WALSH BAY ARTS PRECINCT | STAGE 2 STATE SIGNIFICANT DEVELOPMENT APPLICATION

Peer review of noise and vibration impact assessment

15 February 2017

TH720-02F01 Review of Noise Impact Assessment (r4)

Figure 2: Proposed construction vehicle entry and exit points and access for existing tenants

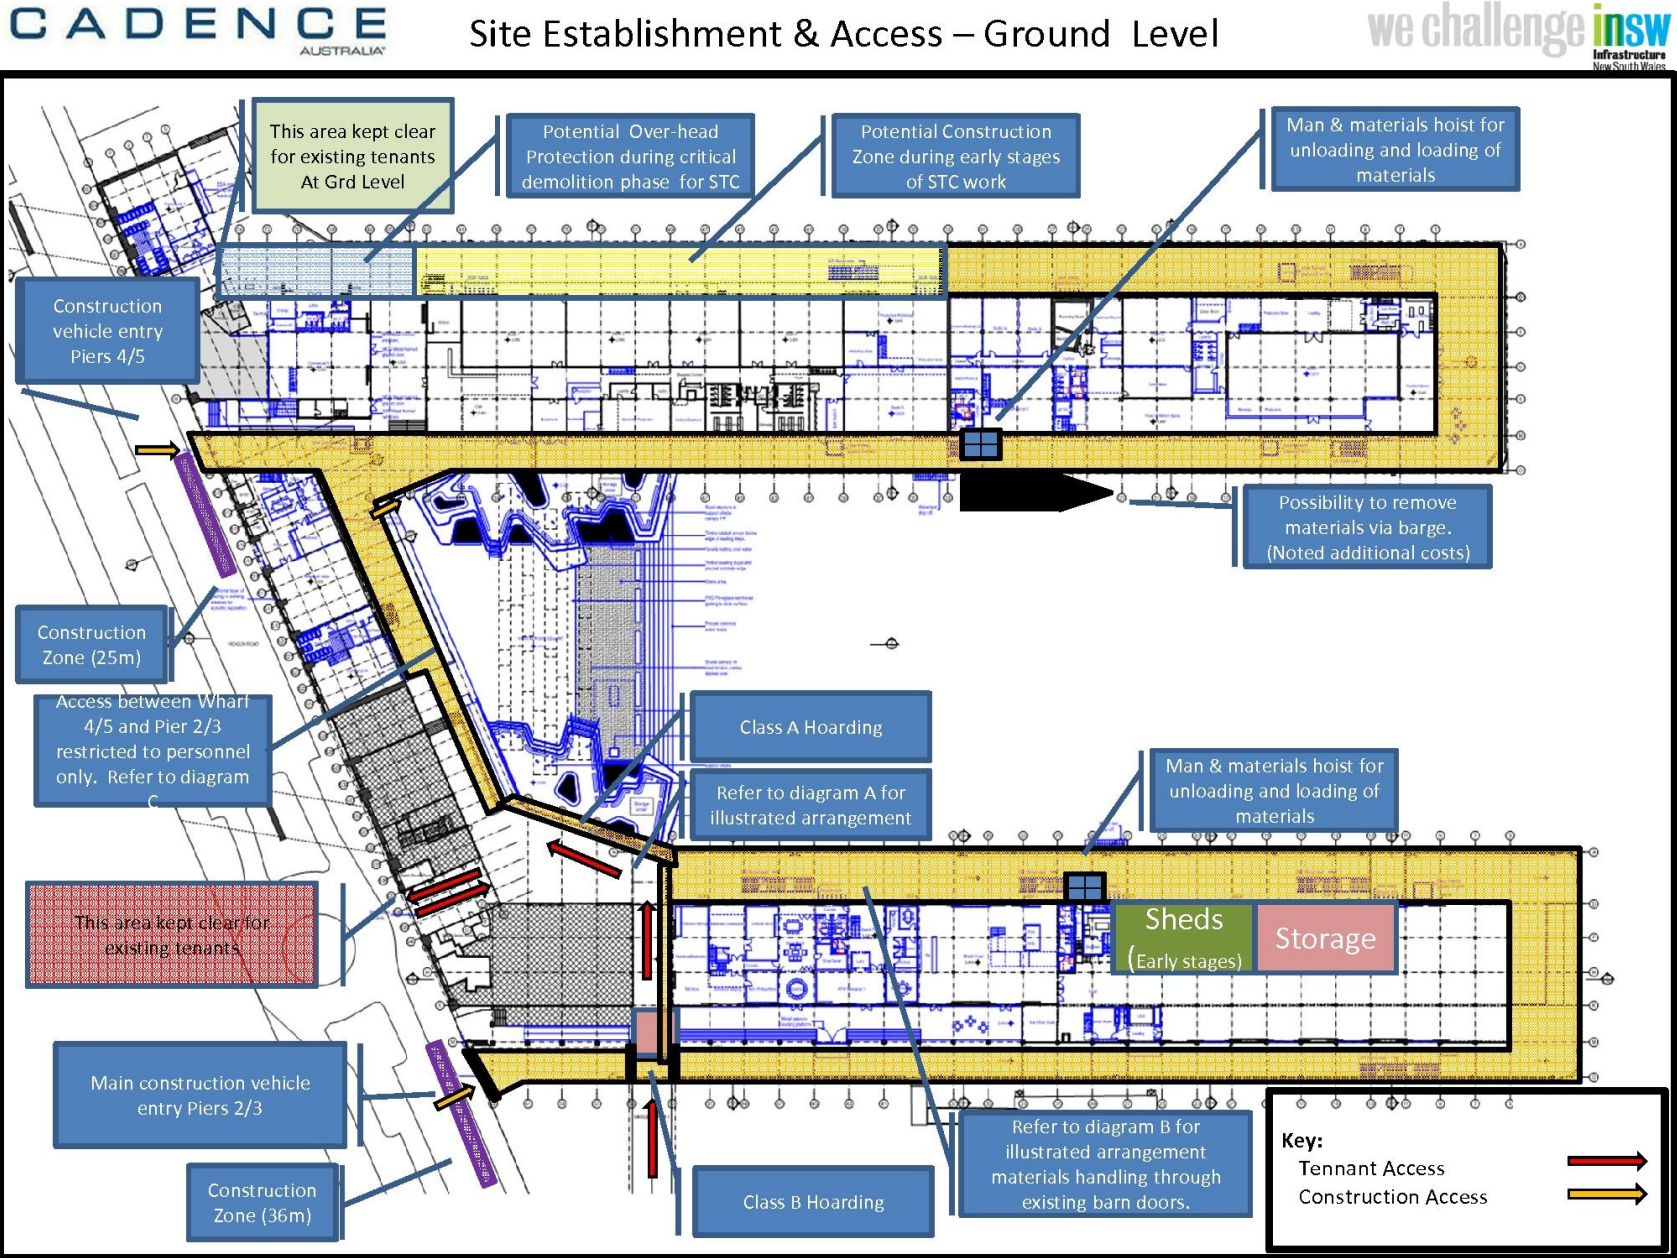
Figure 2 shows the proposed construction access arrangements. The two key construction entry and exit portals are via Pier2 and Wharf 4. The access from Hickson Road via Pier 3 is to be kept free for existing tenants (including SP 73989).

According to Section 6.4.7 of the Arup Report, there will be 40-80 vehicles per day (i.e. 80-160 vehicular movements per day) associated with deliveries and debris removal from the site. It is noted that the construction traffic corridor extends across both the north-west and the eastern facades of SP 73989. Noise impacts from truck traffic entering and leaving the site would therefore be a relevant matter to be addressed.
